Bowmans Creek Wind Farm SSD-10315 - OBJECTION

I Sandra Robertson of [REDACTED] Muscle Creek property No G17-1 strongly oppose the approval of the Bowmans Creek Wind Farm for the below reasons.

**PHOTO NO 1**

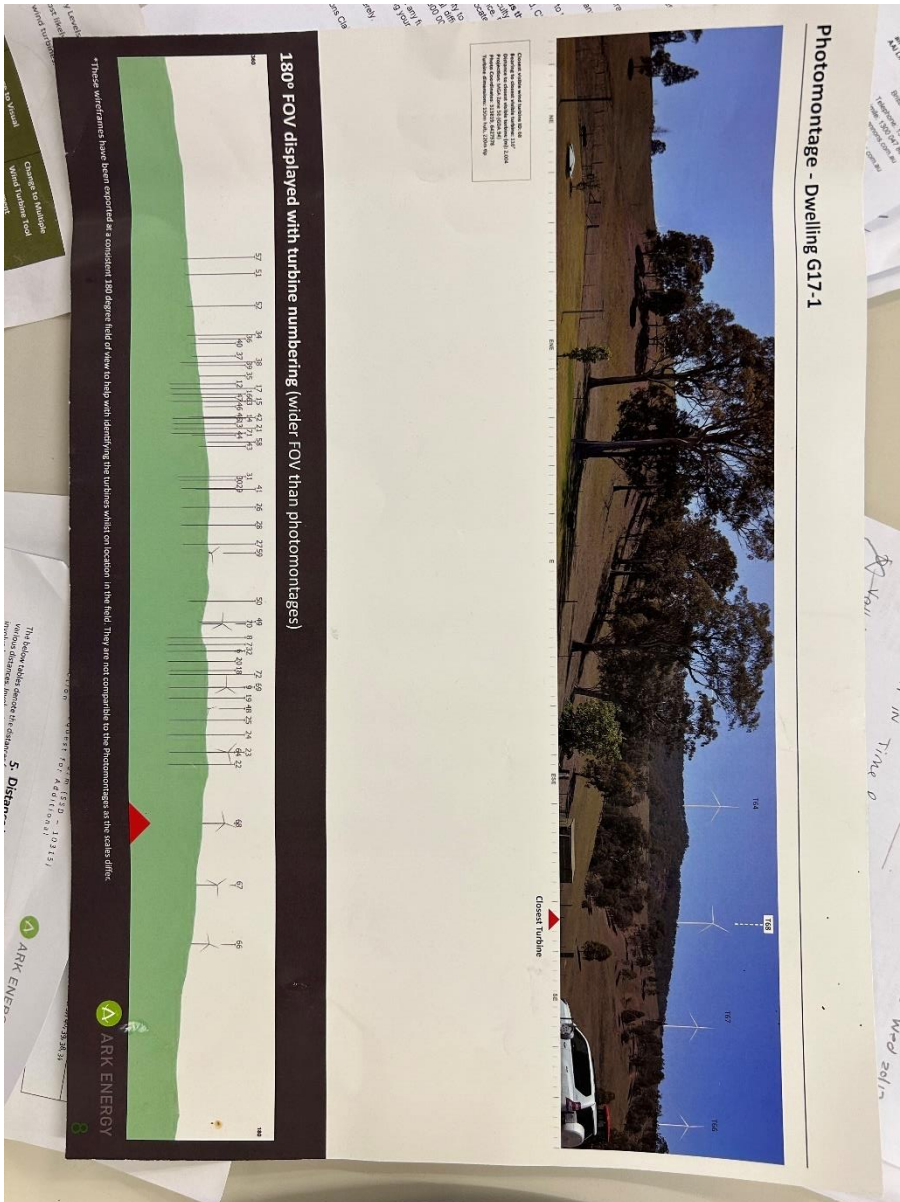
The most recent photo Ark supplied to us in a meeting on 4/10/2023, is attached PHOTO NO 1 & PHOTO NO 1A has marked that Turbine No 68 @ 2004m is the closest turbine to our home, this is incorrect, the Closest Turbine is in fact No 64 and therefore is closer than Turbine No 68 ?, maybe less than the 2km required for a VIZ1 Zone ? Other photomontages have omitted to show the turbines that are to the NE.

**Photo supplied to us at meeting with ARK on 12<sup>th</sup> October 2023**

**Turbine 68 shown at 2004m**

PHOTO NO 1A -close up of the details of turbine No 68 in Photo No 1

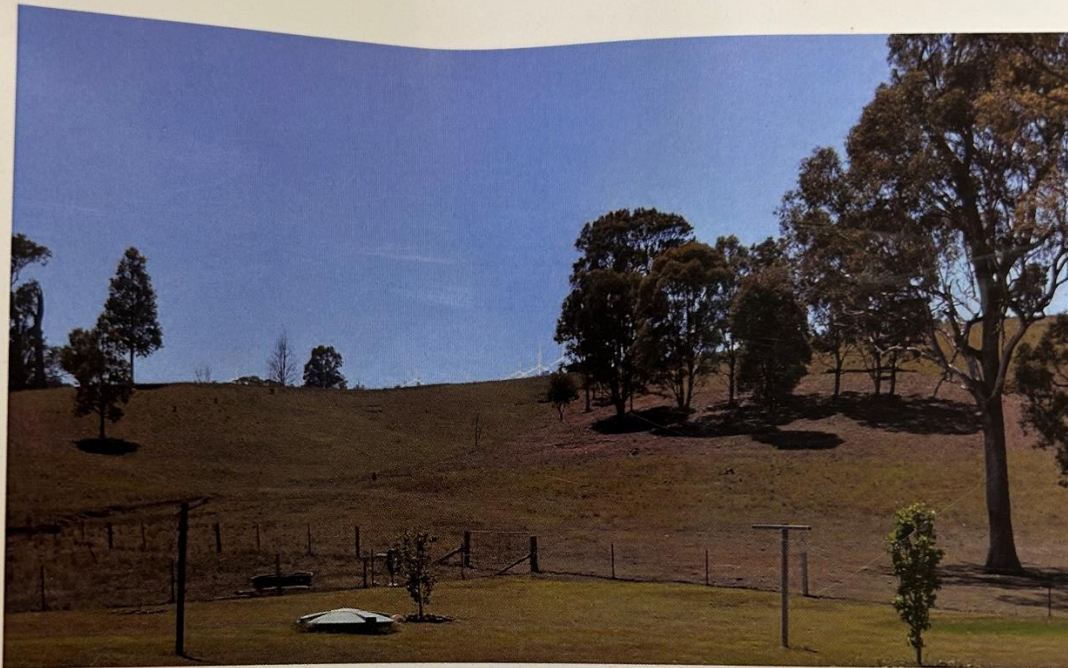
In the EIS Visual Assessment Appendix H Landscape & Visual – Figure 25 PM Dwelling G17-1 It states that Turbine No 68 is the closest visible turbine, which is incorrect.

**PHOTO NO 2**

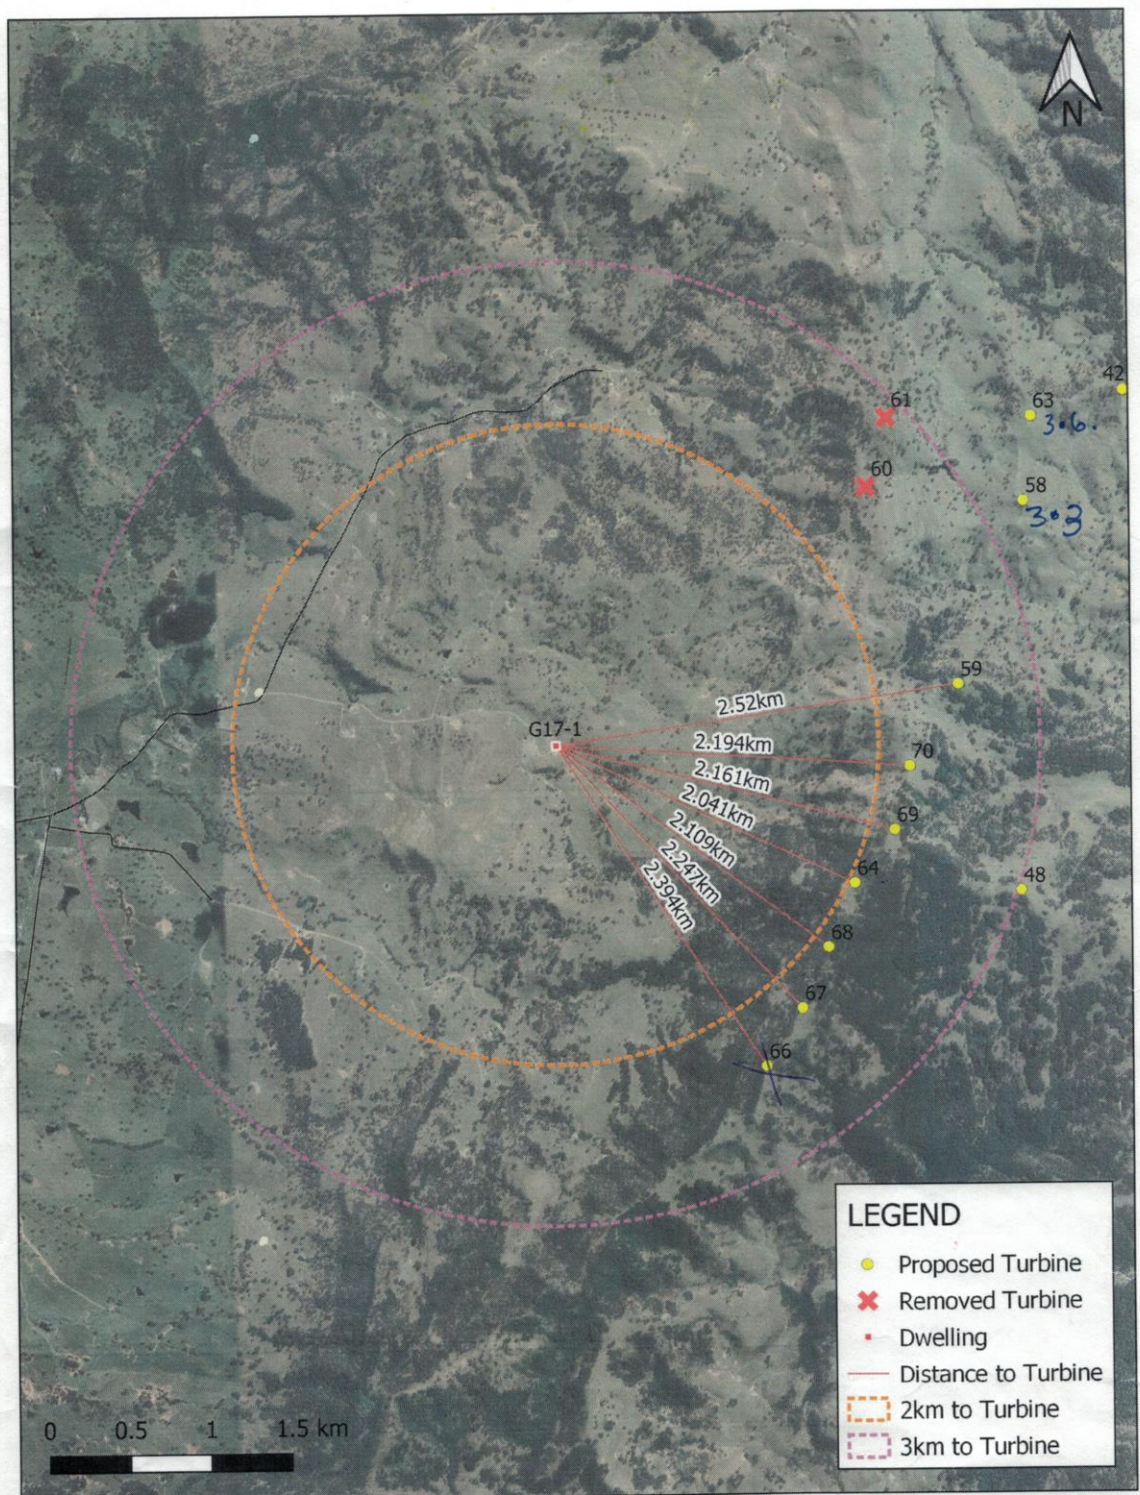
The pole was erected the 30m from the wall of our home and at 7m high as per the Departments recommendation for screening. You took the photos approximately ½ way between the pole and our home. This makes the pole look higher than it is in the landscape and where the turbines are being proposed. The floor height of our home is another 1meter higher which alters the proposed view again. We have taken our own photos on the day you visited from our home lounge room, dining & kitchen and as you can see in the photo I have attached, PHOTO NO 2, the screening will not reach the top of the escarpment let alone the 220 m turbines above that.

The suggested vegetation screening will not mitigate the visual effect from our property as you saw on your visit and as per the photos taken of a pole erected at the distance suggested from our home. (See photo No 2) We would likely be dead before a hedge could get to this height, if ever.

**Photo we took from our kitchen window of the pole we set up for your visit on the 7/12/23, 30m from house, 7metres high, and our home is 1.3 metres off the ground level.**

**This Shows that the screening will not mitigate the visual amenity of all the turbines on the ridgeline from our home.**
